RESPONSIVENESS SUMMARY

SeaTac Development (aka MasterPark Lot C) Site Remedial Investigation/Feasibility Study Report, Draft Cleanup Action Plan, and SEPA Determination

October 2011

FIGURE 4
**LOCATION OF COMPLIANCE
MONITORING WELLS**
SEATAC DEVELOPMENT SITE/RI/FS/WA

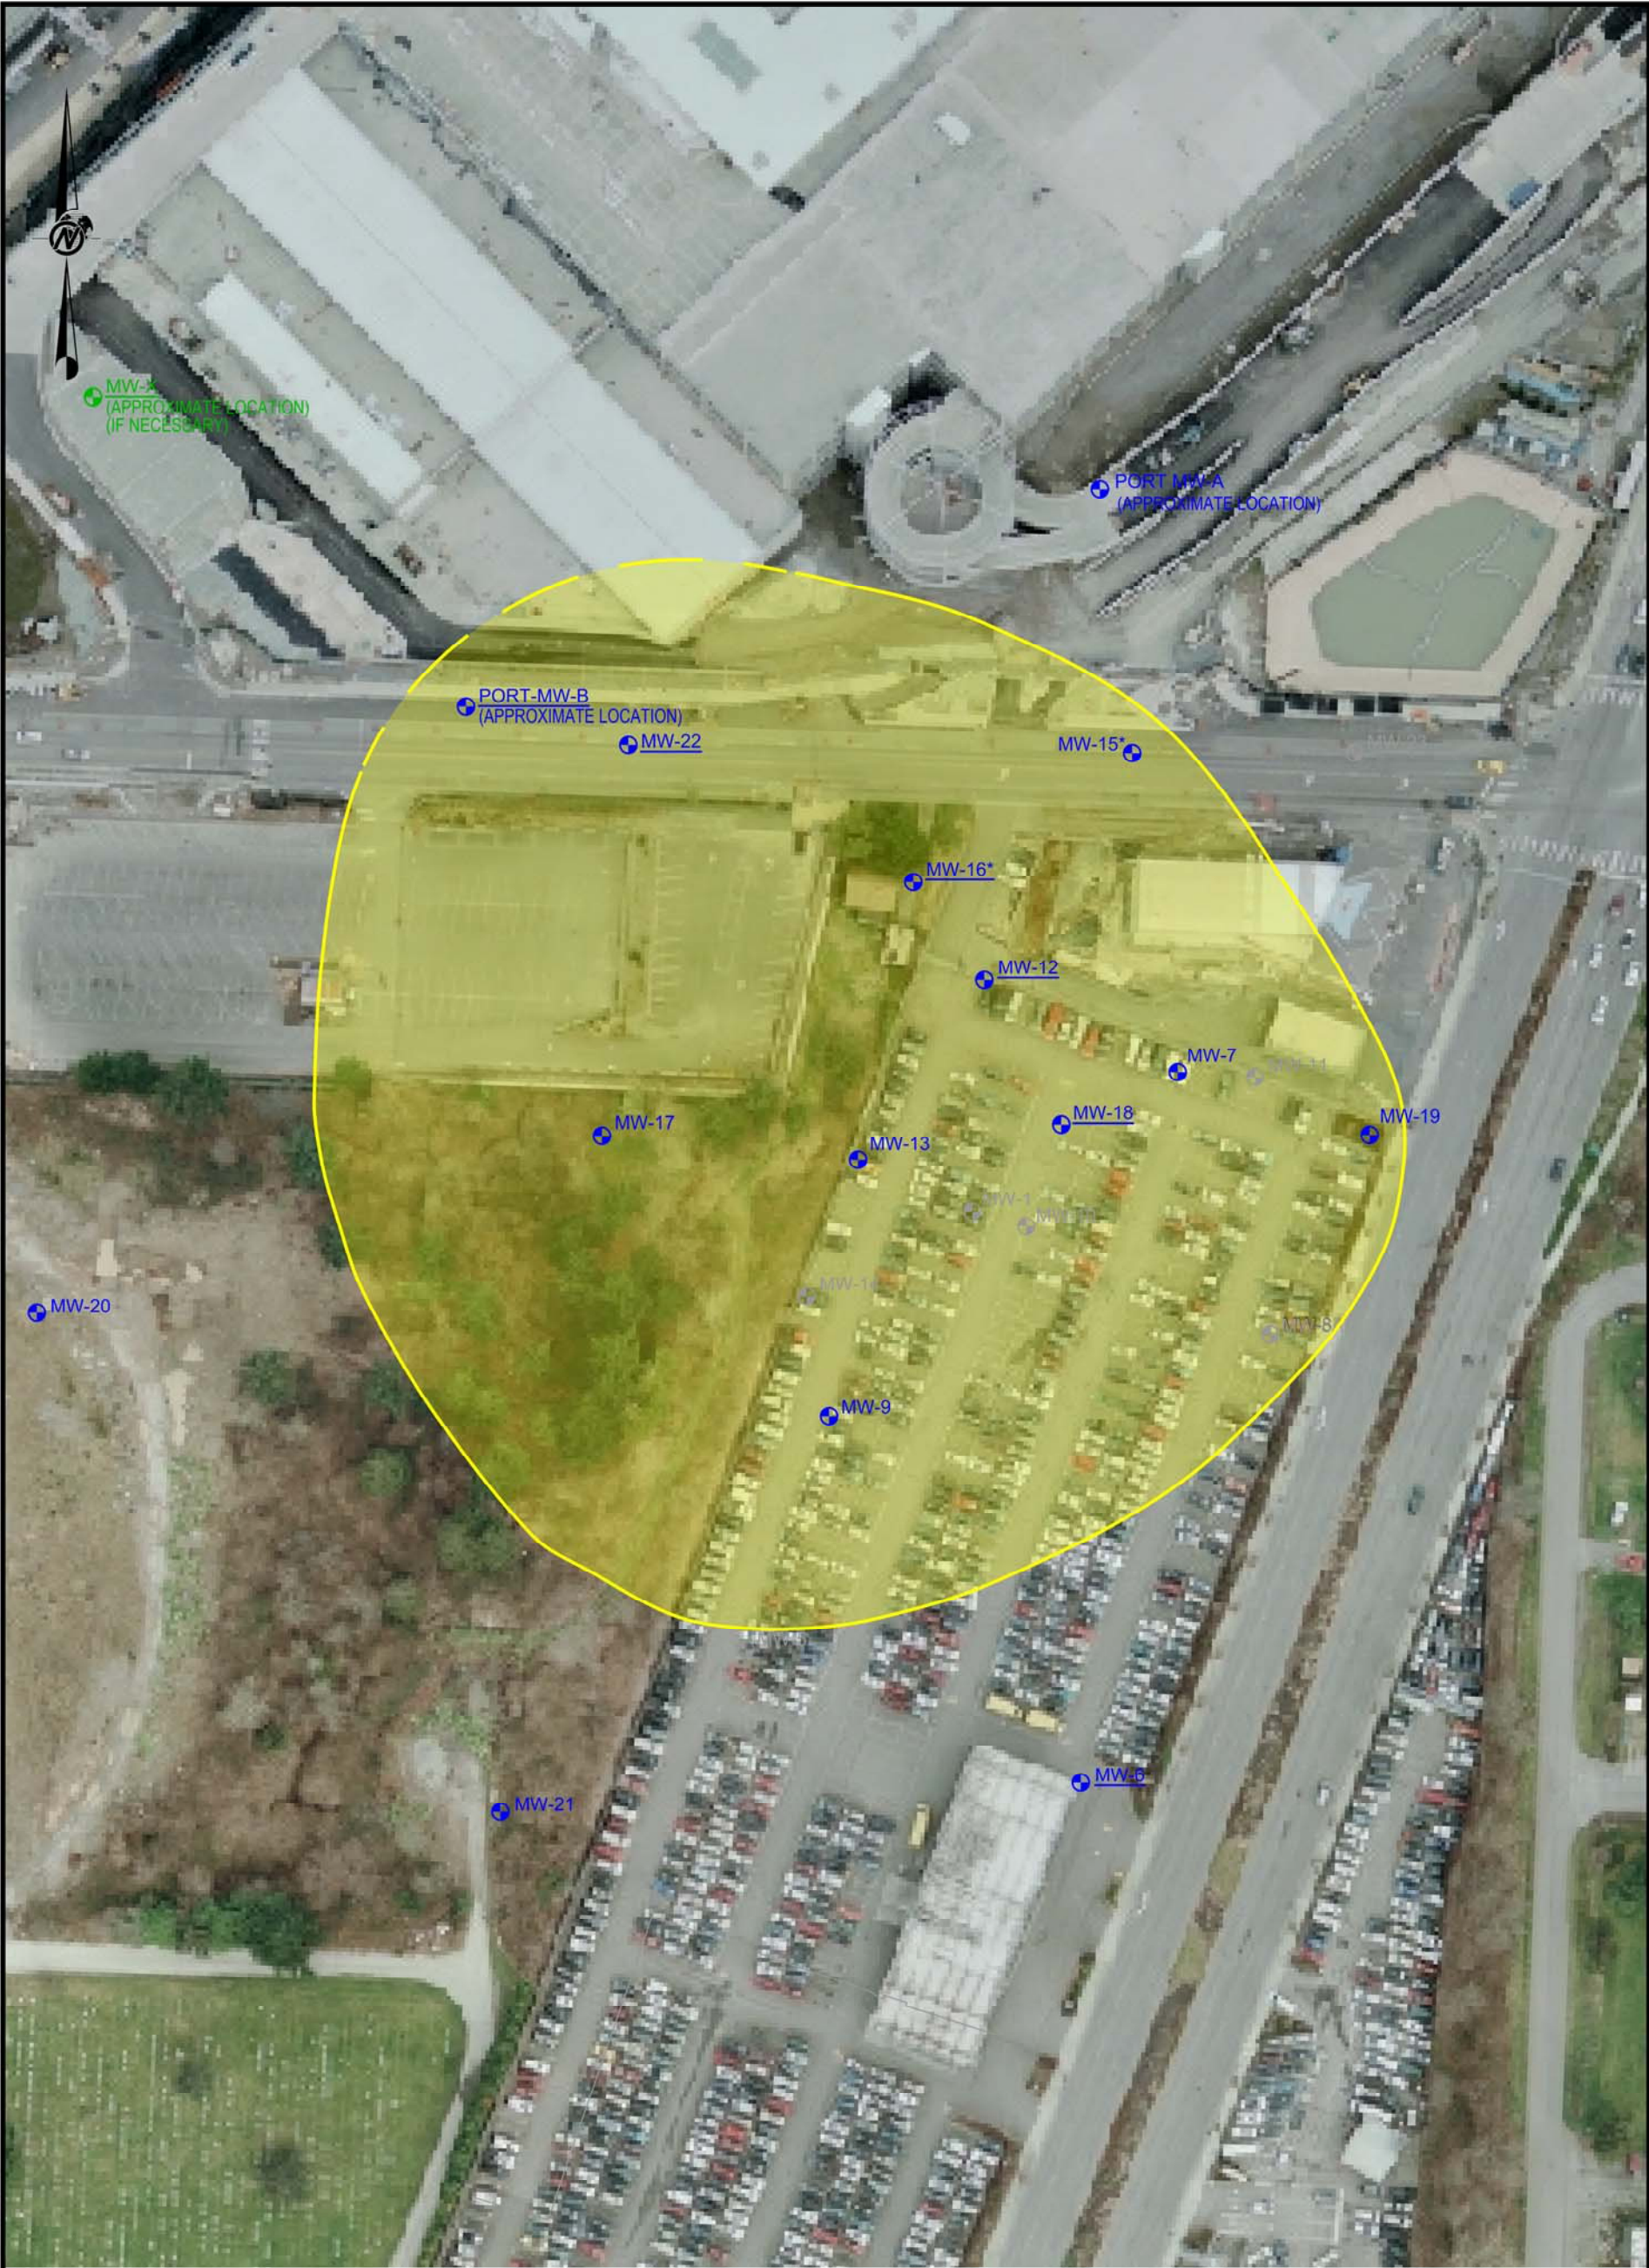
ITEM 12 - Figure 4: What criteria were used to define the plume boundary, particularly near MW-B and MW-A? MW-19 should be included within the plume boundary, given the TPH-G increase to 1300 ug/L in 3/10, the most recent data available.

Ecology's Response: The plume boundary in Figure 4 is estimated based on hydrogeologic and geochemical principles using the applicable MTCA Method A ground water cleanup level for dissolved gasoline (TPH-Gx) and petroleum related compounds. The Addendum will be revised to use the March 2010 plume footprint for TPH-Gx (Figure 4-6 in the RI/FS Report) for Figure 4. This will include MW-19 in the plume boundary.

A monitoring well (designated Port MW-A on attached Figure 4) north of monitoring well MW-15 has been installed and sampled, as agreed during the June 27, 2011 meeting. Port MW-A well did bound the petroleum hydrocarbon plume north of MW-15.
